SUBJECT: FINAL ACCIDENT SEQUENCE PRECURSOR ANALYSIS OF CONDITION AT HADDAM
NECK

B.2 LER No. 213/95-010

Event Description: Multiple safety injection valves are susceptible to pressure locking

Plant: Haddam Neck

Fig. B.2.2. Dominant core damage sequence for LER No. 213/95-010.

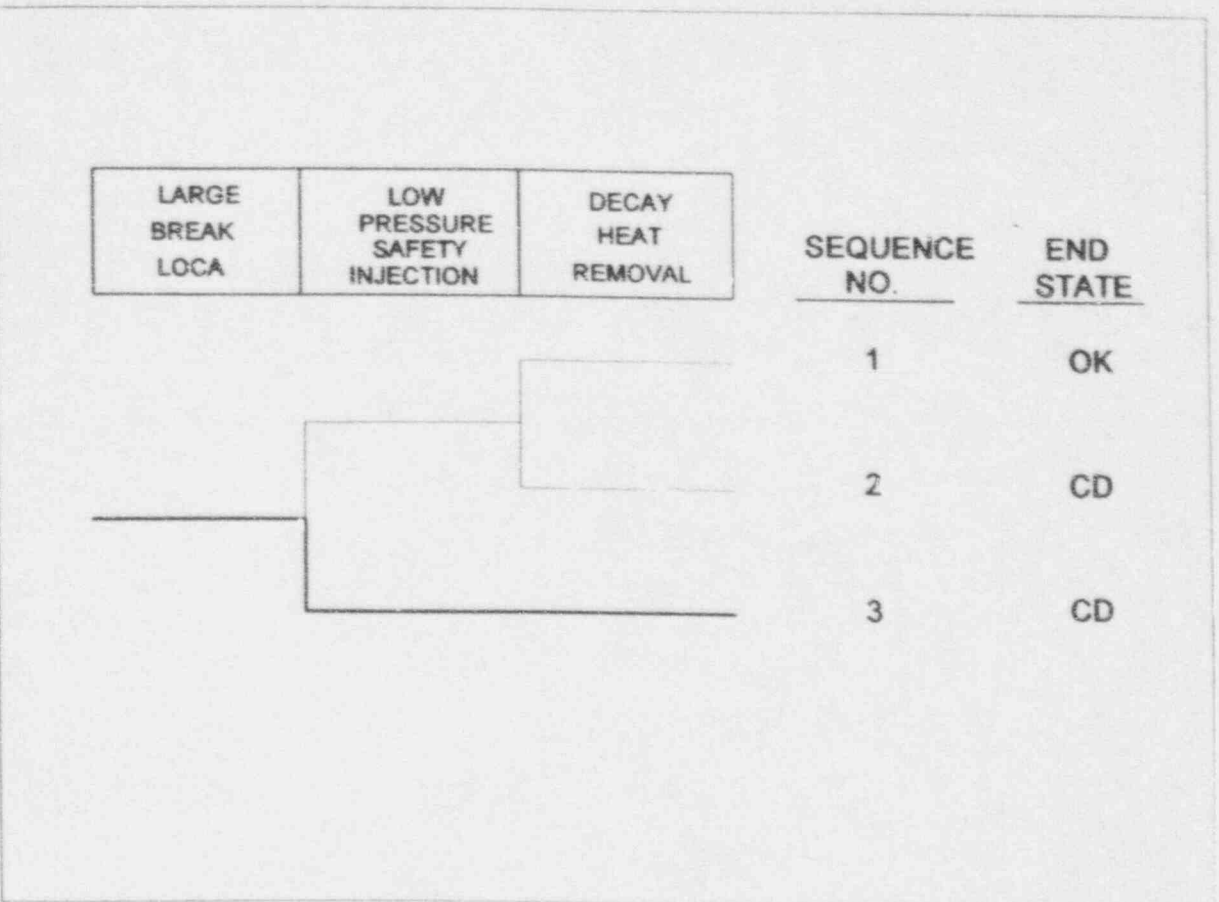
An increase in the core damage probability (CDP) during the time that the necessary conditions for pressure locking these valves exists is 4.7×10^{-6} . The nominal CDP for the same period is 2.1×10^{-6} . The dominant core damage sequence for the event (sequence no. 3 on Fig. B.2.2) involves:

- a postulated large-break LOCA, and
- failure of low-pressure injection.
